Notice of Intent

Type of Action: APD Change

Procedure Description: Engineering Only - Devon Energy Production Company L.P. respectfully requests the following changes to the approved APD: Offline BOP/Stump testing variance request. Batched wells on Red Bull 29 Wellpad 2. Please see attached Break Test Variance_Offline BOP variance request document.

Section 2 - Blowout Preventer Testing Procedure

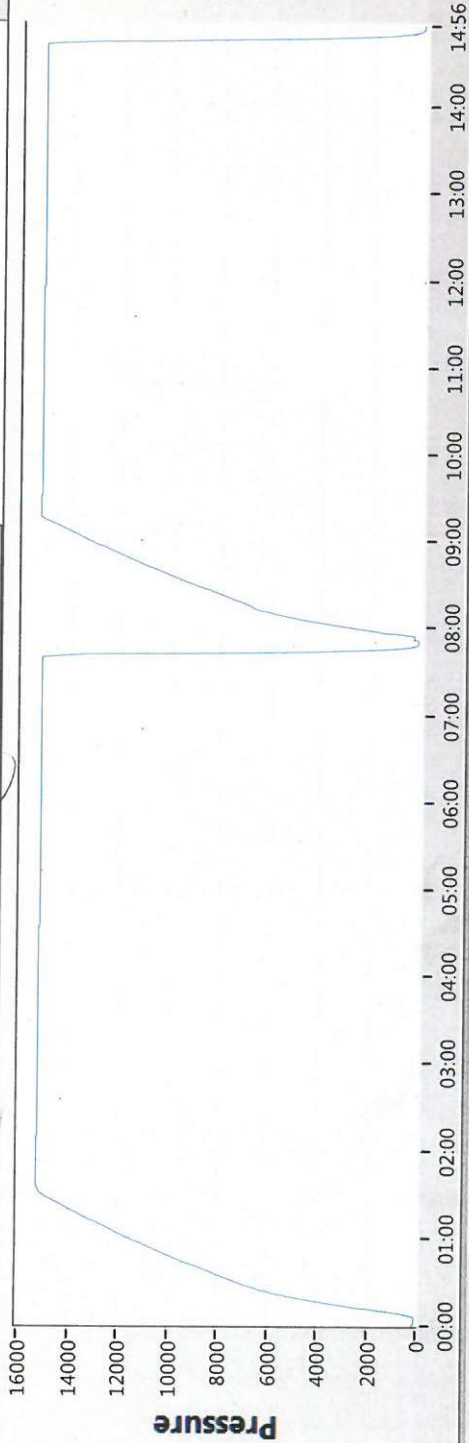
Devon Energy requests to only test BOP connection breaks after drilling out of surface casing and while skidding between wells which conforms to API Standard 53 and industry standards. The initial BOP test will follow 43 CFR 3172, and subsequent tests following a skid will only test connections that are broken. This test will at minimum include the Top Pipe Ram, HCR, Kill Line Check Valve, QDC (quick disconnect to wellhead) and BOP shell of the 10M BOPE to 5M for 10 minutes. Additional pressure testing is required for pressure-containing and pressure-controlling connections when the integrity of a pressure seal is broken. If a break to the flex hose that runs to the choke manifold is required due to repositioning from a skid, the HCR will remain open during the shell test to include that additional break. The variance only pertains to intermediate hole-sections. This variance will meet or exceed 43 CFR 3172 per the following: Devon Energy will perform a full BOP test per 43 CFR 3172 before drilling out of the intermediate casing string(s) and starting the production hole, testing the Annular during initial BOP testing to a minimum of 70% RWP and higher than MASP, and pressure testing at a 21-day interval frequency. The BLM will be contacted 4hrs prior to a BOPE test. The BLM will be notified if and when a well control event is encountered. In the event break testing is not utilized, then a full BOPE test would be conducted.

Devon Energy requests to perform offline BOP stump testing and offline BOPE testing. All pressure-containing and pressure-controlling seals will be tested either online or offline as denoted in the table below and per BLM approval during initial BOP test following test pressure requirements set forth in 43 CFR 3172. Remaining components not tested offline or on the stump will be tested within 72-hours when the BOP is connected to the wellhead. If stump testing exceeds 72-hour window prior to connecting to the wellhead, the BLM will be notified and either stump testing restarted, or the BOP being tested online. The BLM will be contacted 4hrs prior to a BOPE test. The BLM will be notified if and when a well control event is encountered. In the event stump testing is not utilized, then a full BOPE test would be conducted.

Devon requests offline BOPE testing for the following components: Upper Rams, Blind Rams, Kill Valves, Choke Valves, and Annular

All Previous COAs Still Apply. Variance request procedure is approved as written, please see below general conditions for variance.

BOPE Break Testing Variance

- BOPE Break Testing is ONLY permitted for 5M BOPE or less. **(Annular preventer must be tested to a minimum of 70% of BOPE working pressure and shall be higher than the MASP)**

- BOPE Break Testing is NOT permitted to drilling the production hole section.
- Variance only pertains to the intermediate hole-sections and no deeper than the Bone Springs formation.

Operator has been **(Approved)** to test the BOPE offline.

The BOPE offline testing shall be stationary during pressure testing.

Online BOPE testing should commence within 72 hours of offline BOPE testing completion. Notify the BLM if interval exceeds 72 hours.
